Planning Report

Links at Ballantrae

Case Summary

Agenda Item	1
Case Number	13-057FDP/FP
Site Location	North side of Rings Road, approximately 1,100 feet west of Eiterman Road.
Proposal	The development and a subdivision plat for 45 single-family lots and approximately 7 acres of open space.
Applicant	Jason Francis, M/I Homes; represented by Jeff Strung, EMH&T.
Case Manager	Claudia D. Husak, AICP, Planner II (614) 410-4675 chusak@dublin.oh.us
Requests	Review and approval of a <u>final development plan</u> under the provisions of Zoning Code Section 153.050.
Planning Recommendation	<p>Review and recommendation of approval to City Council for a <u>final plat</u> under the provisions of the Chapter 152, Subdivision Regulations.</p> <p>In Planning's opinion, this proposal complies with all applicable review criteria and the existing development standards and approval is recommended with one final plat condition.</p> <p>Final Development Plan: Approval Final Plat: Approval with 1 Condition</p>

13-057FDP/FP
Final Development Plan/Final Plat
The Links at Ballantrae
Rings Rd

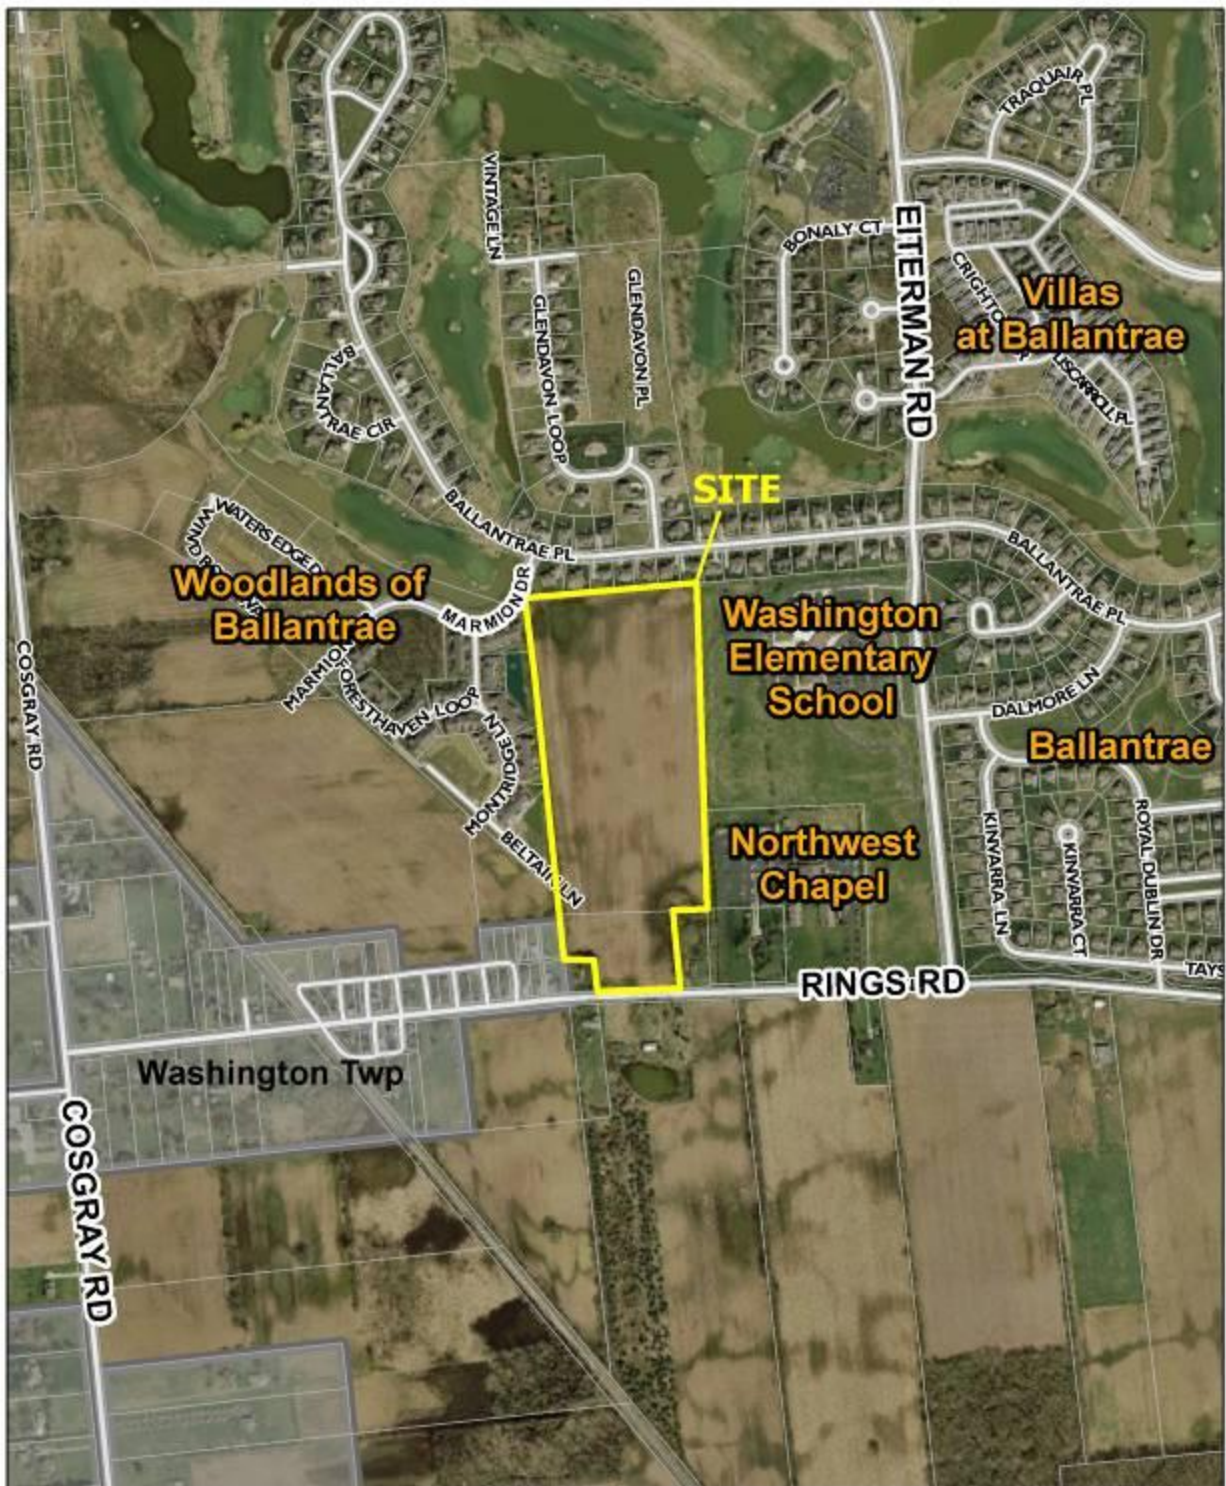
Condition	<p><u>Final Plat</u></p> <p>1) That the applicant ensure that any minor technical adjustments to the plat, including the addition of the road name for Churchman Road are made prior to City Council submittal.</p>
